**Tillbridge Solar Project
EN010142**

**Volume 9
Statement of Common Ground with Trent Valley
Internal Drainage Board
Document Reference: EN010142/APP/9.14**

**April 2025
Revision Number: 02**

Figure 1: Trent Valley Internal Drainage Board Crossings

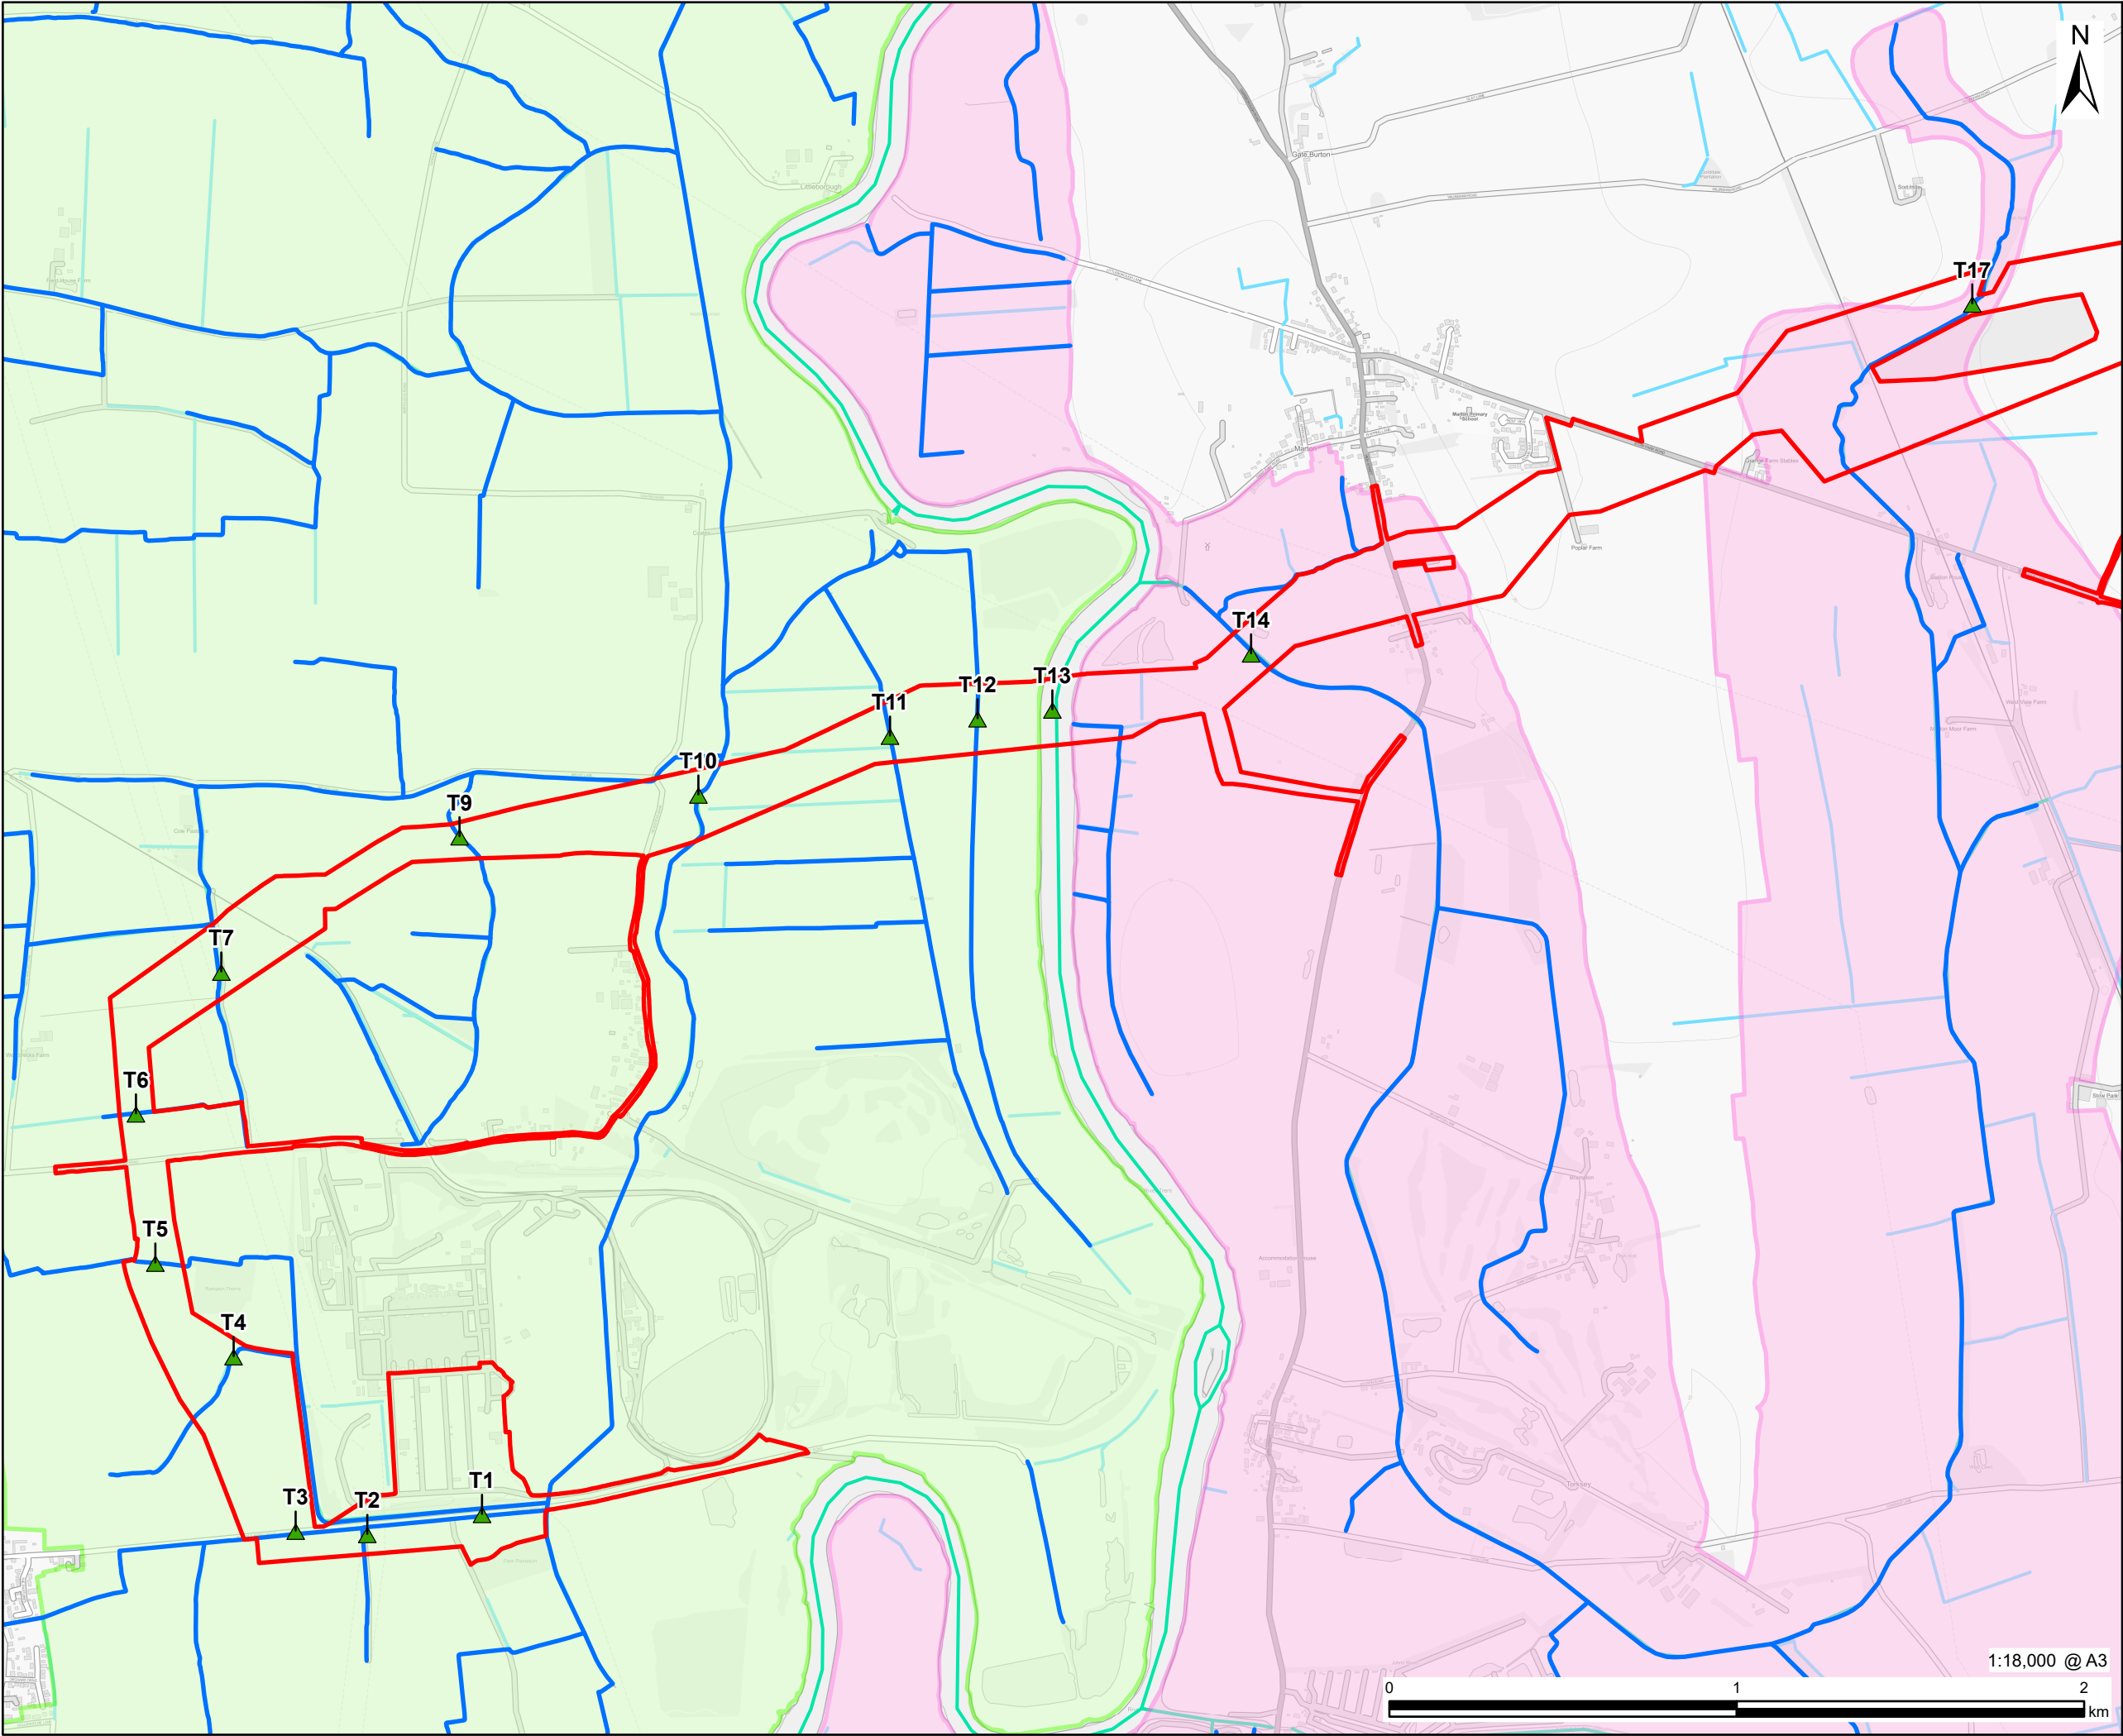
Ref.	Relevant Application Document	Description of Matter	Status	Likelihood of Resolution
Additional Consultation September 2023				
1.1	Chapter 10: Water Environment of the ES [EN010142/APP/6.1(Rev01)]	<u>TVIDB's Comment:</u> All Channels in TVIDB to be crossed using trenchless (non-intrusive) techniques. <u>Applicant's Response:</u> This has been included within the Scheme design. This is stated within Section 10.7 Embedded Design Mitigation of Chapter 10: Water Environment of the ES [EN010142/APP/6.1(Rev01)], set out within the Framework CEMP [EN010142/APP/7.8 (Rev01)] and the location of the crossings is illustrated by Figure 1 within Appendix A of this SoCG.	Agreed – TVIDB comment has been resolved	Resolved
